Please amend the paragraph starting on line 12 of page 5 of the specification as follows:

Please amend Fig. 5 as shown on the enclosed drawing with the proposed changes marked in red. A substitute drawing sheet showing the amended Fig. 5 is enclosed herewith.

REMARKS

Fig. 5

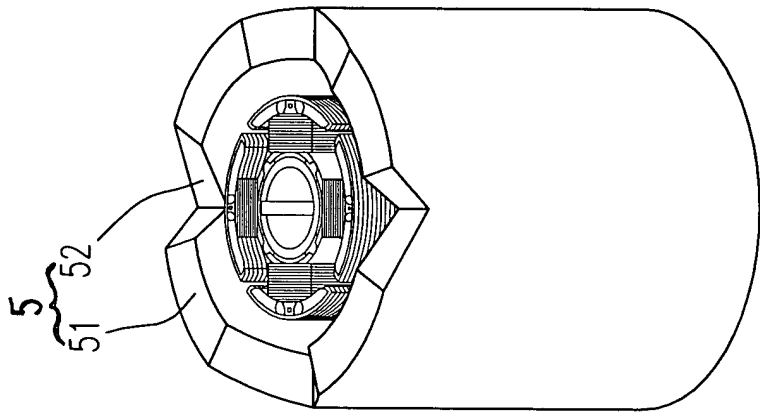
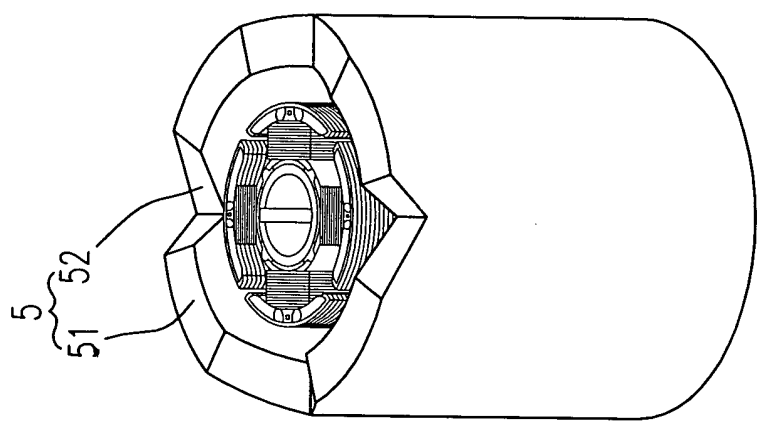
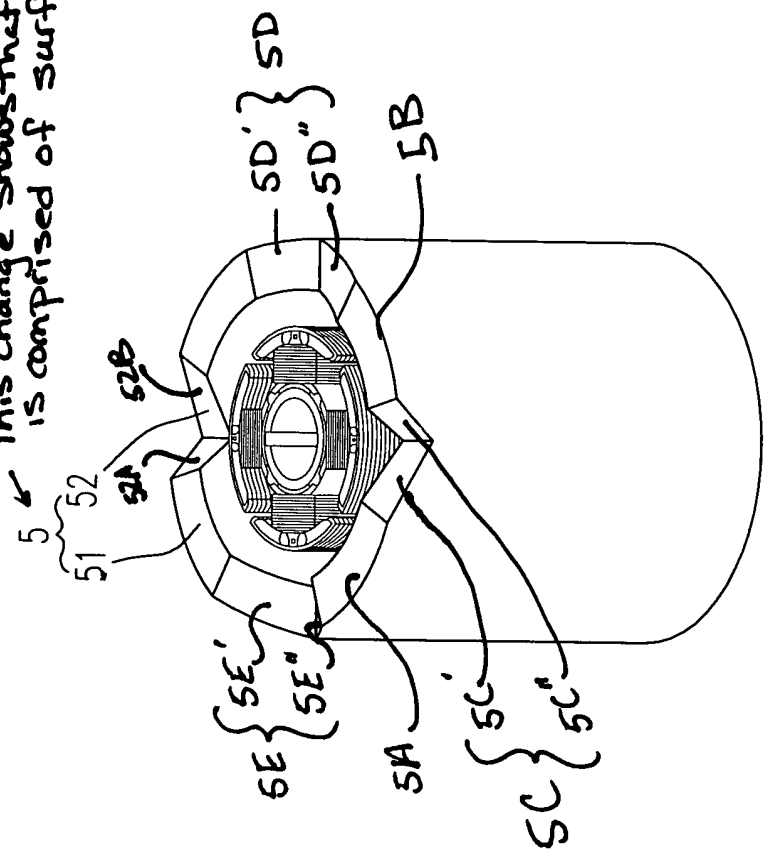
To address the Examiner's concern, applicants have amended the specification to recite an irregular lumpy edge 5 as stated in claims 9 and 11 as originally filed, and have further amended reference number 5 in Fig. 5 to show that the lumpy edge comprises the concave and convex surfaces, 51 and 52, as stated on page 5, lines 15-16 of the specification as filed, i.e., "a lumpy edge which is a combination of a plurality of concave surfaces 52 and a plurality of convex surfaces 51." The reference number 5 in amended Fig. 5 clearly shows that it refers to both reference numbers 51 and 52. For purposes of illustrating the irregularity of the edge 5 in Fig. 5 as filed, applicants also submit a copy of Fig. 5 as originally filed, marked to show features illustrating the irregularity of the edge. Note in the portion numbered 5A, the outer edge forms a curve having a different arc than the outer curve of the section marked 5B. Note also that the section marked 52 has two faces, 52A and 52B which are of different surface areas and that both slant down and inwardly towards the inside surface of the rotor. The opposite section, marked 5C in the enclosed copy of Fig. 5, is also comprised of two faces 5C' and 5C", one having a larger surface area (5C') than the other (5C") and both sloping down, but outwardly towards the outer side of the rotor. Surface 51 as the specification states is convex, curving upwards. The section denoted by

number 5D has two faces, 5D' and 5D" that appear to be roughly equal in surface area. The opposite section, marked as number 5E also has two faces, 5E' and 5E", but they are not equal in surface area. Section 5E' is clearly shown to be larger in surface area than section 5E". The foregoing detailed analysis of Fig. 5 demonstrates that the Figure clearly illustrated from the time the application was filed, that the edge 5 is lumpy and irregular. Thus, the introduction of the term "irregular" in the claims is not new matter. The irregularity of the lumpy edge has been part of the application from the time of filing and was clearly in the possession of the applicants at that time. Moreover, the claims form part of the specification, so the fact that the original claims included this feature is further evidence that applicants had possession of this aspect of the invention at the time of filing the application.

5 ← This change shows that the lumpy edge 5
 is comprised of surfaces 51 and 52.

With the amendment to Fig. 5, the feature of the rotor having a magnet cylinder with an irregular lumpy edge is now more clearly discernable in the drawing and in the specification. Therefore, the amended specification and revised Fig. 5 provide support for the claimed feature. Reconsideration and withdrawal of the §112 rejections of Claims 9 and 11 are respectfully requested.

Fig. 6

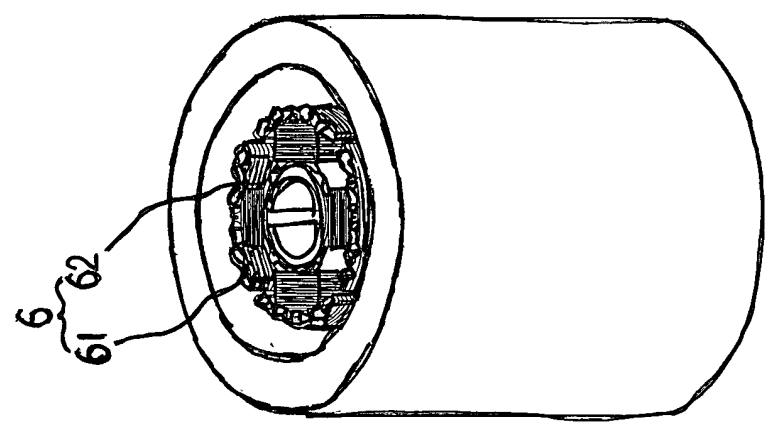
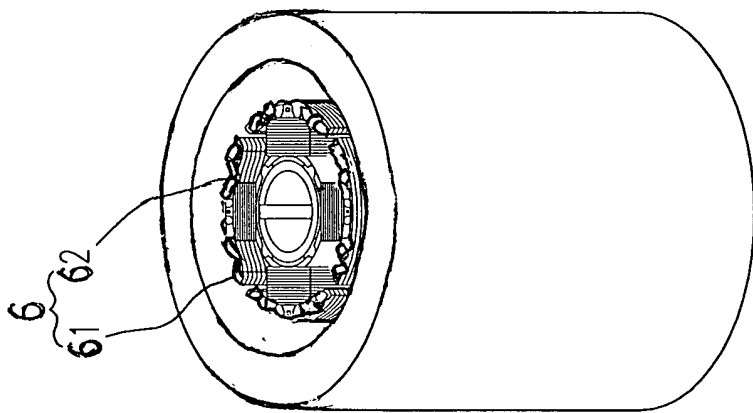
Please add new Fig. 6 as shown on the enclosed drawing sheet. A proposed Fig. 6, shown in red, is enclosed as well as a back and white version of Fig. 6.

New Fig. 6 is submitted herewith to illustrate the subject matter of claim 11. Basis for the structure shown in Fig. 6 can be found in the specification at page 3, lines 19-24 and at page 5, lines 16-19 describing a "stator magnet ... wherein the stator has a magnet cylinder with a lumpy edge which is a combination of a plurality of concave surfaces and a plurality of convex surfaces." Thus, no new matter is introduced by the amendment to the specification or the addition of Fig. 6.
